## **CORPORATION OF THE CITY OF VERNON**

### **ADVISORY PLANNING COMMITTEE**

**WEDNESDAY, OCTOBER 10, 2018**

**SUBJECT: DEVELOPMENT VARIANCE PERMIT APPLICATION FOR 3904 29<sup>th</sup> STREET**

**PROPOSED DEVELOPMENT ON LOT 5, BLOCK 1,  
SEC 3, TP 8, ODYD, PLAN 383 MOUNTAIN VIEW.**

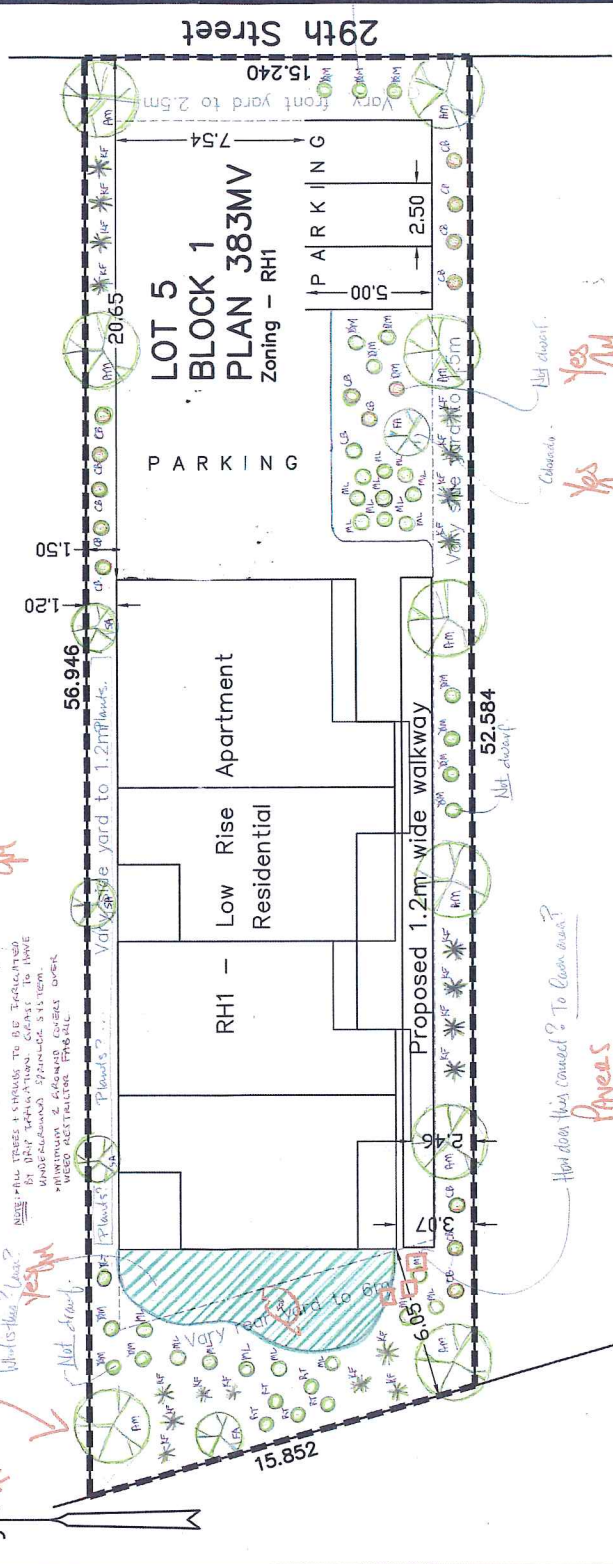
Needs a Legacy Tree 1 per 10

Not dwarf -  
dwarf? need to go  
low buffer  
then some spacing/speckles

Planted? ... Vary wide yard to 1.2m plants.

How does this connect? To lawn area?

Plants?

Plants?

Plants?
